Recall Bulletin

PRODUCT SAFETY RECALL

SUBJECT: Shift Lever Indicator May Not Display Correct Gear

MODELS: 2008-2010 Chevrolet Malibu
2008-2010 Pontiac G6
2007-2010 Saturn AURA
Equipped with 4-Speed Automatic Transmission (ME7/MN5)

3256032

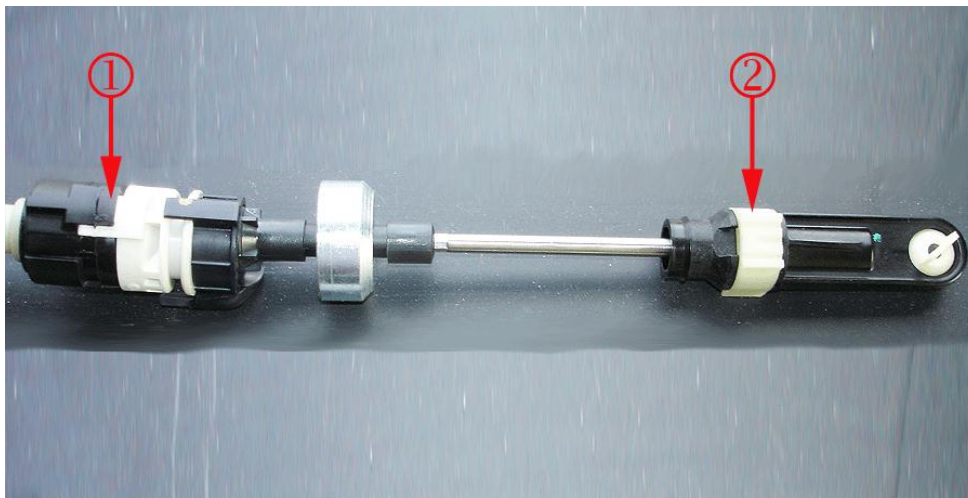
Note: Perform the service repair procedure in this bulletin on second design transmission shift cables only. First design transmission shift cables do NOT require a repair. Refer to the illustration to view a first design shift cable. Refer to *Transmission Shift Cable Kit Installation Procedure* in this bulletin to view the second design transmission shift cable.

2269489

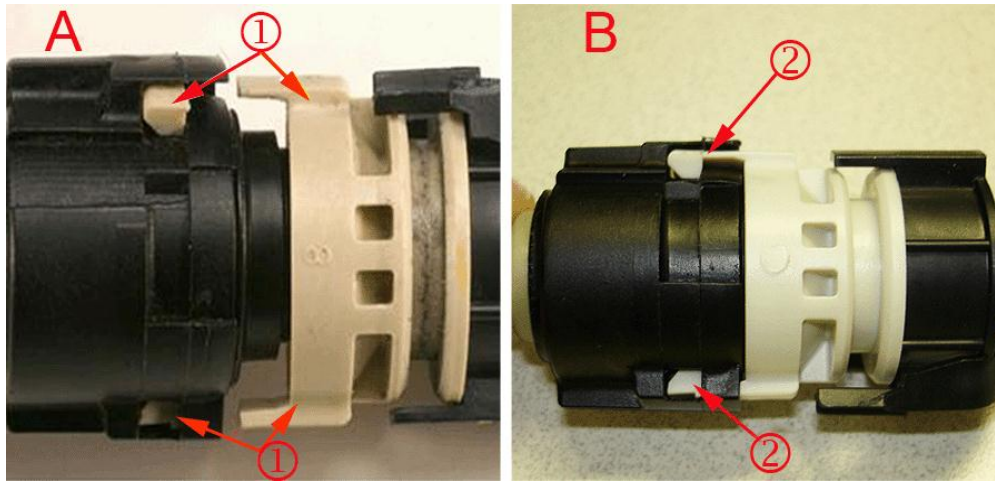
- (1) Shift Cable Locking Tabs
- (2) Shift Cable Adjuster Locking Clip

1. Open the hood and locate the transmission shift cable.
2. Determine if the transmission shift cable locking tabs are fractured and separated.
